FCC Class II Permissive Change Application Letter

Product name : Wireless Chime
FCC ID: 2ASIVPGA381
Date of Grant: 05/11/2022
Model No.: PGA381

Change Contents: update the components on main board as below:

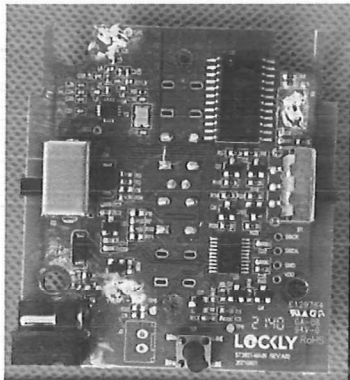
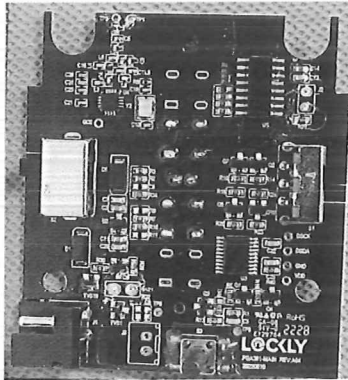
Location	Old PCB of FCC ID: 2ASIVPGA381	New PCB of FCC ID: 2ASIVPGA381
Voice IC		
	IC: NY5P055BS24	IC: NY5Q92AS16
Optimize the PCB layout; The new chip has the same basic function as the old chip; The circuit changes have no effect on the radio parameters. PCB board solder mask color changed from green to black;		
Modifications that do not change the fundamental RF characteristics and that do not degrade the unwanted emissions of the certified product, please refer to test report for more details; Modifications that do not change physical characteristics significantly. We attach new photographs to identify the modified product.
